Doc Type: Working Group Document
Title: Discussion of Mro Dandas
Source: Martin Hosken
Action: For consideration by JTC1/SC2/WG2 and UTC
References: N3589R
Date: 2011-03-17

Introduction: The Mro script was accepted to be added to a future ammendment of ISO 10646 as specified in N3589R (L2/09-097R). But during the review process some questions were raised as to the nature and requirements for the two danda characters in the proposal: .. MRO DANDA U+16A6E, and ... MRO DOUBLE DANDA U+16A6F. This document addresses those concerns, justifying their encoding as specified in N3589R.

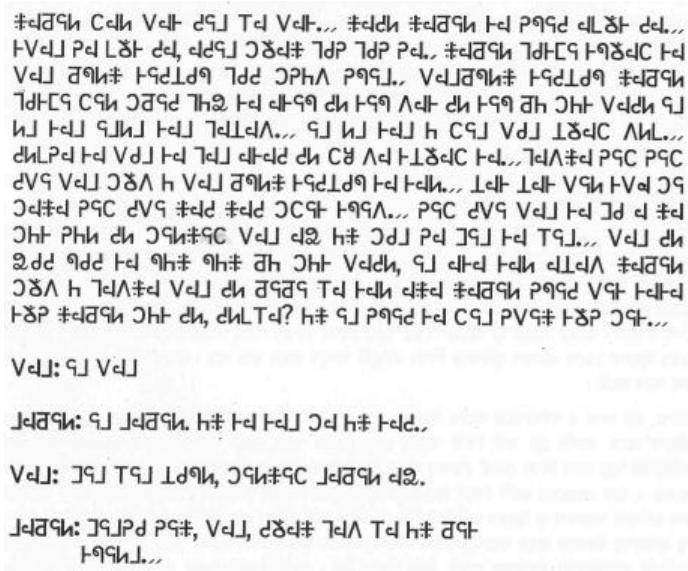
Notice the occurrence of a single .. MRO DANDA U+16A6E at the end of the third paragraph. There are other occurrences in the first paragraph as well.

The issue of the use of a . FULL STOP U+002E as found at the end of the fourth paragraph was raised with the community. There is some uncertainty among authors as to whether to use western punctuation (full stop and comma), or local punctuation (dandas), or whether to mix the two systems. The contrast here is between two

punctuation systems, the Westerns with full stop and comma, and the Mro with danda (dot-stroke) and double danda (dot-stroke-stroke). The dot in the Mro dandas is an integral part of each, not a Western full stop plus a stroke or plus two strokes. This is exemplified by the main example font having different shapes for the dot used in the danda (round) and the full stop (square, also the shape used in the colon, etc.).
